Product Change Notification / JAON-04WEXT659

CCB 4832 Final Notice: Implement top marking changes for selected ATZBRF233, ATSAMR21G18, ATWILCxxxx, ATWINCxxxx, ATSAMW25H18, RN2483A and WFI32E01xx device families available in various module packages.

CCB 4832
Pre and Post Change Summary
PCN# JAON-04WEXT659

Pre and Post Change Summary – Marking

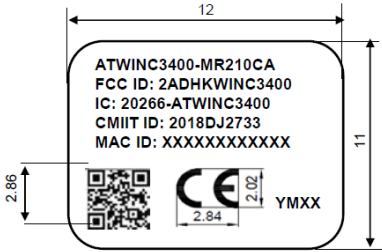
Affected CPNs	Pre Change	Post Change	Changes
<p>ATWILC1000-MR110UB ATWILC1000-MR110UB-T</p>			<p>Date code format (YMXX to YYWWNNN); Add UKCA logo</p>
<p>ATWILC3000-MR110CA</p>			<p>Date code format (YMXX to YYWWNNN); Add UKCA logo</p>

Pre and Post Change Summary – Marking

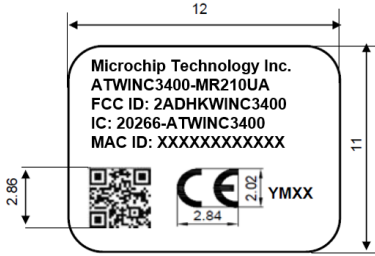
Affected CPNs	Pre Change	Post Change	Changes
<p>ATWILC3000-MR110UA ATWILC3000-MR110UA-T</p>	 <p>Microchip Technology Inc. ATWILC3000-MR110UA FCC ID: 2ADHKWILC3000U IC: 20266-WILC3000UA MAC ID: F8F005DDDA96</p> <p>QR code, CE, 9HF7</p>	 <p>Microchip Technology Inc. ATWILC3000-MR110UA FCC ID: 2ADHKWILC3000U IC: 20266-WILC3000UA MAC ID: F8F005626E22 2132TPT</p> <p>QR code, CE, UKCA</p>	<p>Date code format (YMXX to YYWWNNN); Add UKCA logo</p>
<p>ATWINC1500-MR210PB1952 ATWINC1500-MR210PB1954 ATWINC1500-MR210PB1961 ATWINC1500-MR210PB1944 ATWINC1500-MR210PB ATWINC1500-MR210PB1172 ATWINC1500-MR210PB1140 ATWINC1500-MR210PB1961-T ATWINC1500-MR210PB1965-T ATWINC1500-MR210PB1952-T</p>	 <p>ATWINC1500-MR210PB FCC ID: 2ADHKATWINC1500 IC: 20266-WINC1500PB CMIIT ID: 2018DJ1305 ANATEL: 08497-18-08759 MAC ID: F8F0057000AD</p> <p>QR code, CE, 0ISR</p>	 <p>ATWINC1500-MR210PB FCC ID: 2ADHKATWINC1500 IC: 20266-WINC1500PB CMIIT ID: 2018DJ1305 ANATEL: 08497-18-08759 MAC ID: F8F0056ECB7E 2132TPT</p> <p>QR code, CE, UKCA</p>	<p>Date code format (YMXX to YYWWNNN); Add UKCA logo</p>
